Introduction:

A total of 23 comment sheets were received between the time of the Open House Meeting and the deadline for comment submission, May 29, 2013.

Question 1: Please rank each bridge rail option in order of preference (1 – 4; where 1 is most desired and 4 is least desired):

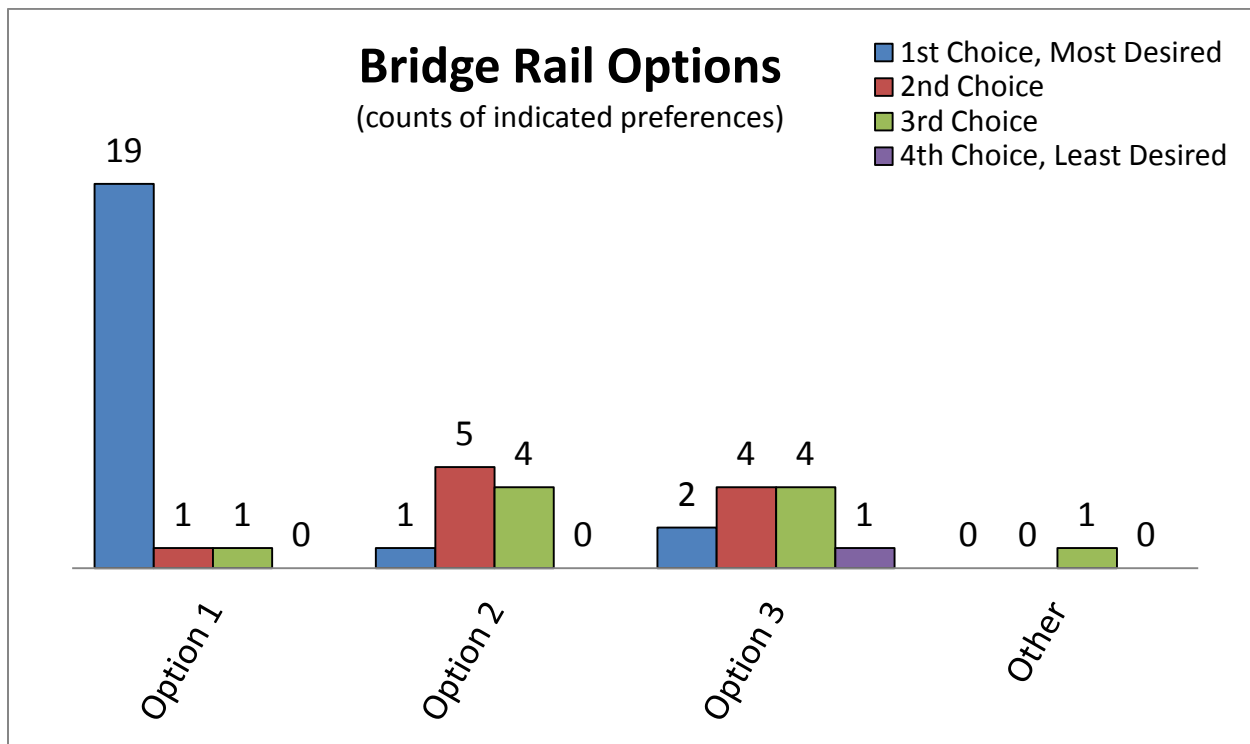
The one comment for "Other" read:

I prefer the options that appear to give more character and blend with the "complete streets" and "wayfinding" projects currently underway in Barnette, Cushman, and Noble Streets.

- The preferred bridge rail was option 1, the two-tube pedestrian rail on a concrete vehicle rail, similar to the railing on the Barnette Bridge. This conclusion is supported by direct rankings and by written comments.

**Question 2: Please rank each luminaire option in order of preference
(1 – 4; where 1 is most desired and 4 is least desired):**

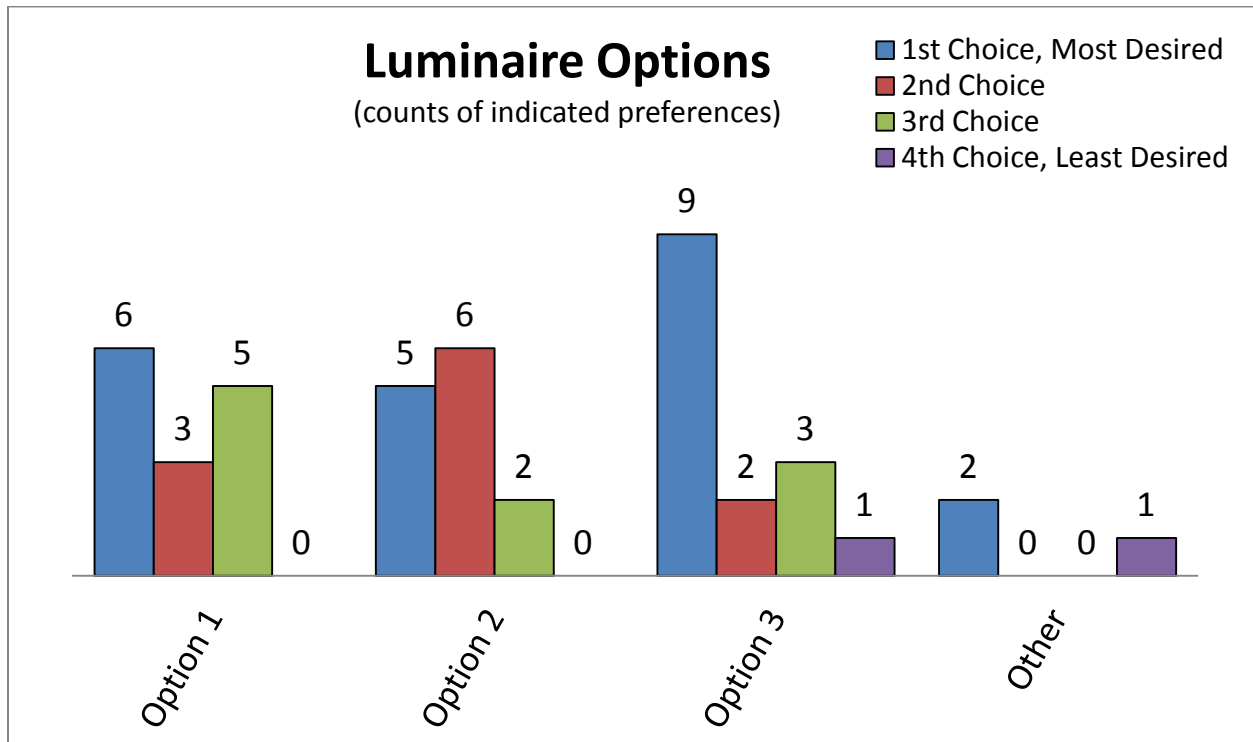
The two comments for “Other” ranked as “1” read:

Light poles consistent with pedestrian path.

I think it would be beneficial to coordinate with the City of Fairbanks on the "complete streets" theme.

The one comment for “Other” ranked as “4” read:

Prefer lights that have arms for banners. Sidewalk illumination is important.

- We are encouraged to consider lighting options that have or do the following:
 - Illuminate the underpass pathway, ramps and sidewalk, not just the roadway.

- Focus light onto the roadway, path and sidewalk to prevent light scatter and pollution.
 - Have a distinctive look and feel about them.
 - Have poles that are consistent with those on the pedestrian path, possibly matching the Griffin Park lighting.

- Match the theme from the City of Fairbanks “complete streets” and “way finding” concepts.
 - Are capable of having decorative or informational banners attached to either the masts or the poles.

- Are inexpensive to maintain.
 - Should be LED type for lower consumption of electricity and thus, lower operating cost.
- We are encouraged to consider accommodating the ability to hang banners on light poles or across the bridge similar to the banner feature on the Barnette Bridge.
